Re: Docket No. 70-925; License No. SNM-928  
Redefining the Licensed Area

ATTACHMENT 1  
PROPOSED REVISED FIGURES 6-1 THROUGH 6-3  
*FACILITY DECOMMISSIONING PLAN – REV 1*

ATTACHMENT 2  
PROPOSED REVISIONS TO SECTION 6.3  
*FACILITY DECOMMISSIONING PLAN – REV 1*

**FIGURE 6-1  
LICENSED AND CONTROLLED AREAS IN  
THE WESTERN AREA  
FACILITY DECOMMISSIONING PLAN  
REVISION 1**

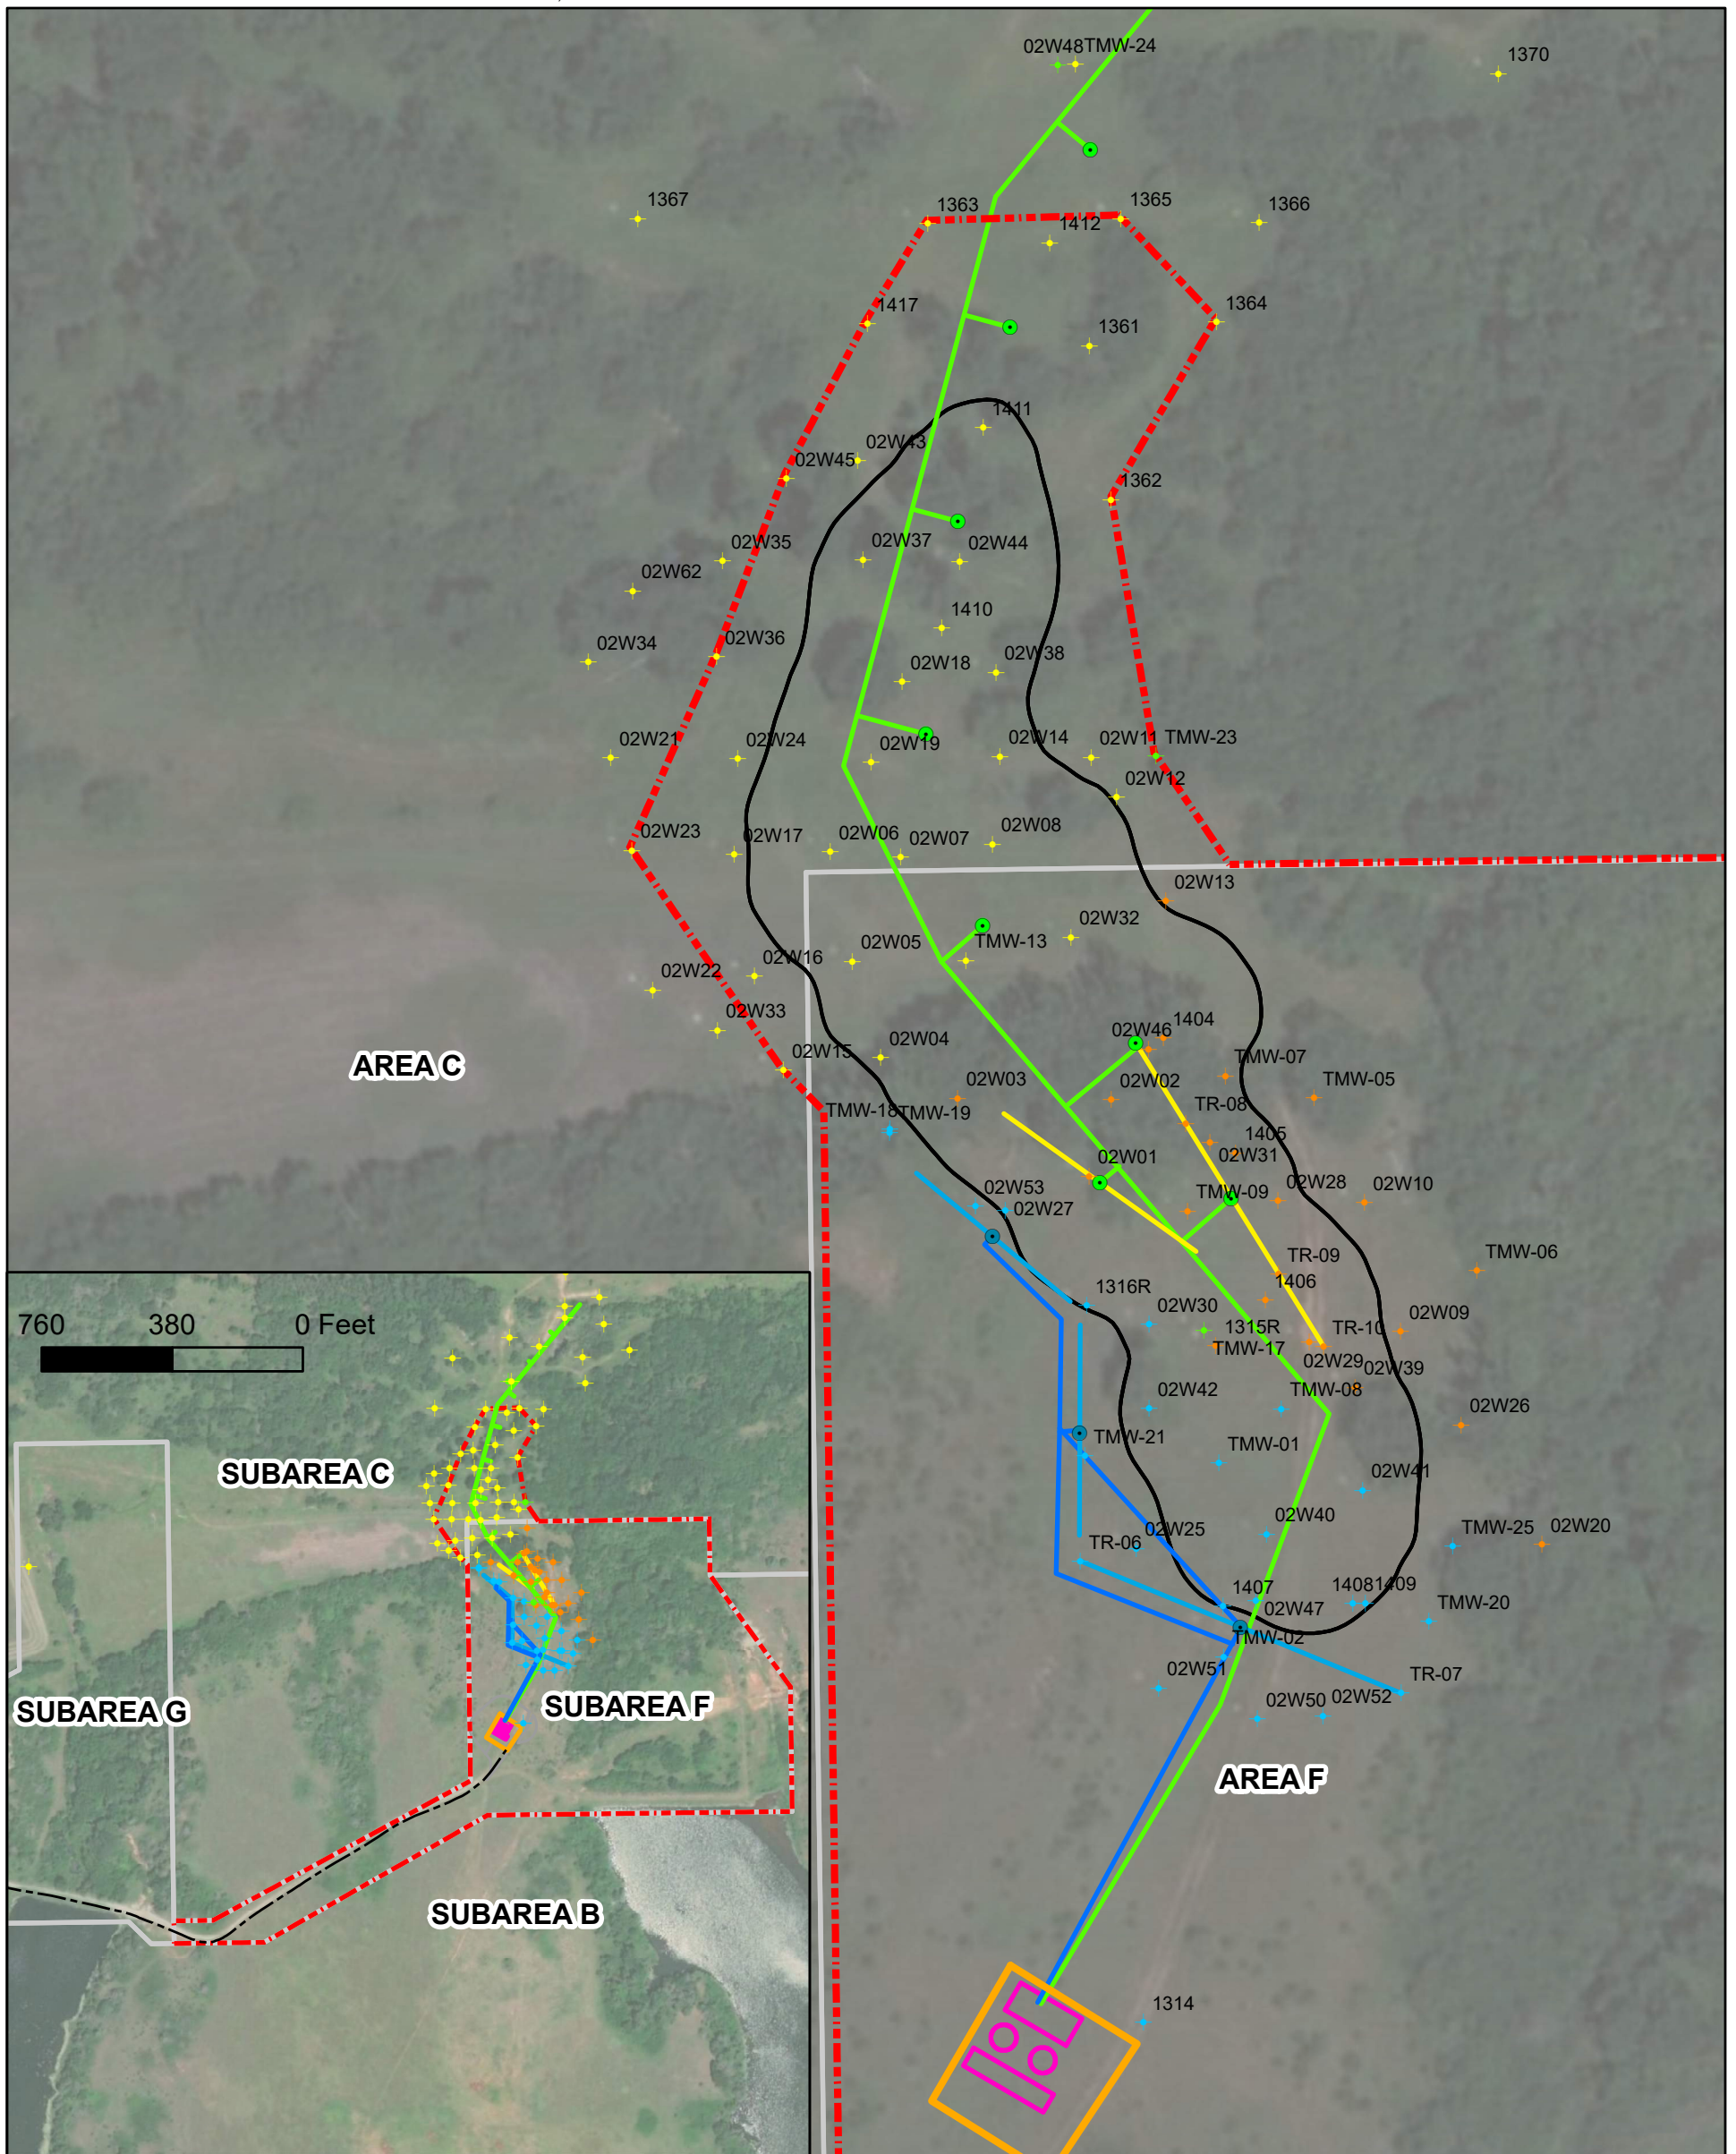
The proposed licensed area in the western portion of the Site was depicted in Figure 6-1 of the DP. The proposed licensed area in the eastern portion of the Site was depicted in Figure 6-2 of the DP. During their review of the DP, NRC personnel observed that those figures, while delineating the proposed areas that would be under license, did not show the extent of groundwater which contains uranium that exceeds the license criteria. Consequently, it is difficult for NRC personnel to confirm that the proposed licensed areas do include all the areas within which groundwater exceeds license criteria.

Attachment 1 to this letter provides revised Figures 6-1 and 6-2 for the DP. The proposed revised figures include Subarea boundaries and isopleth lines that depict the extent of uranium in groundwater exceeding license criteria.

The proposed licensed area in the western portion of the Site is shown in Figure 6-1. Figure 6-1 shows that portions of Subareas D, E, G, H, M, N, and O will be included in the proposed licensed area in the western portion of the Site. It also shows the extent of groundwater in which uranium exceeds 100 µg/L (from Figure 3-3). Because the DCGL is equivalent to approximately 119 µg/L, Figure 6-1 shows that the proposed licensed area will include all groundwater exceeding the DCGL, plus a buffer area.
